Detailed Site Plan

DSP-20032

Addition to Signature Club at Manning Village

SUBJECT: Detailed Site Plan DSP-20032
 Type 2 Tree Conservation Plan TCP2-033-2023
 Addition to Signature Club at Manning Village

Figure 3: Live & Work rear-loaded 20-foot-wide townhouse unit

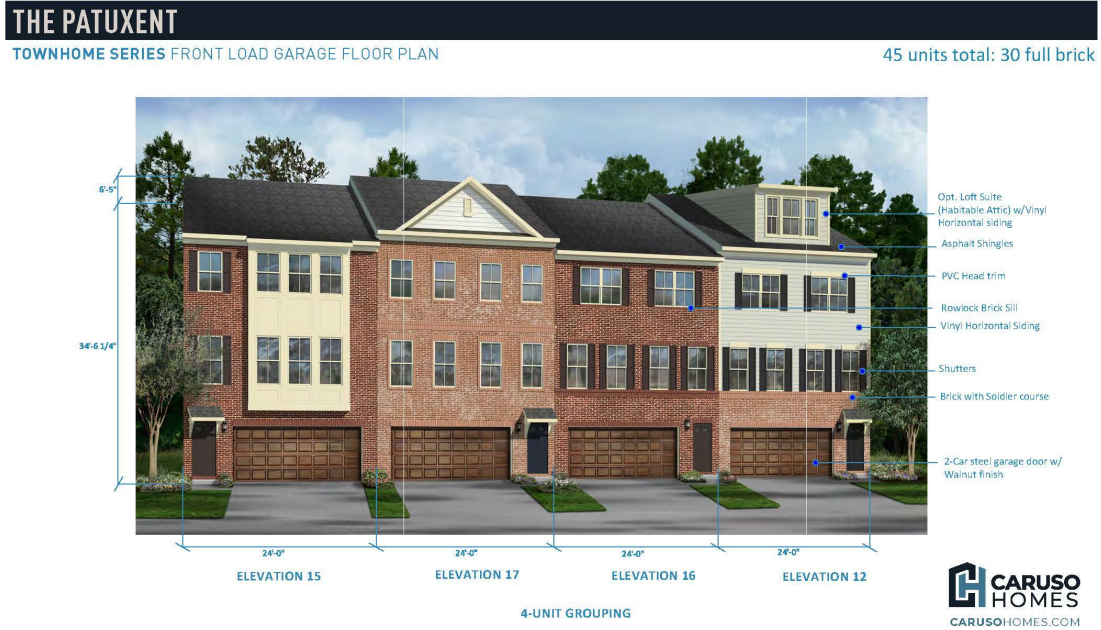
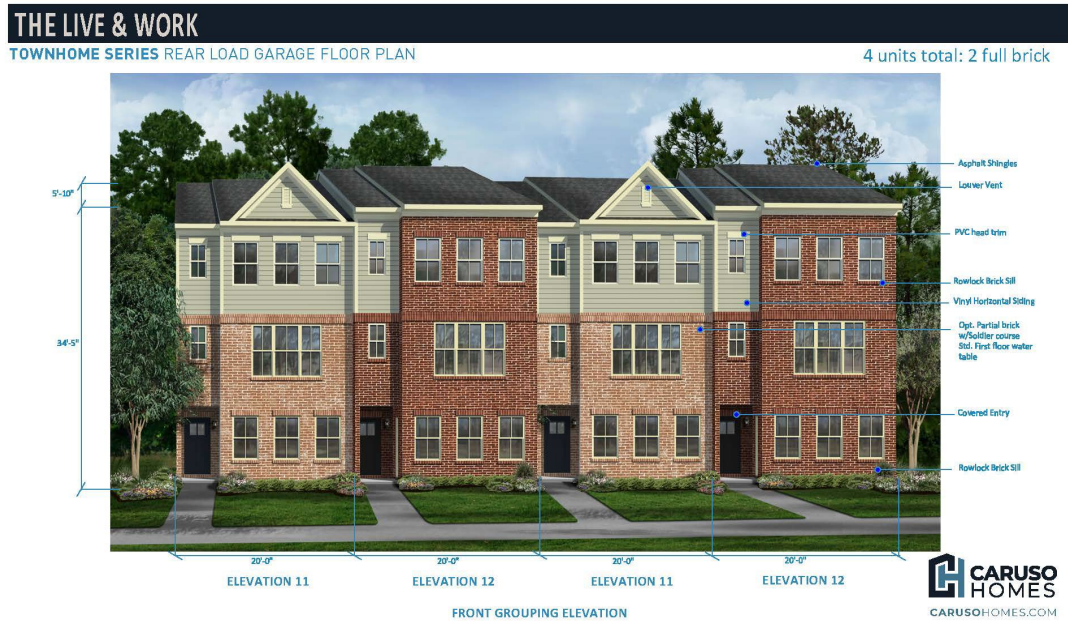
- g. Label the Magothy model as 20 feet wide and the Patuxent model as 24 feet wide on the Architectural Details sheet.
- h. Label Lot 15 in Block A as a highly visible lot on the Architectural Details sheet.
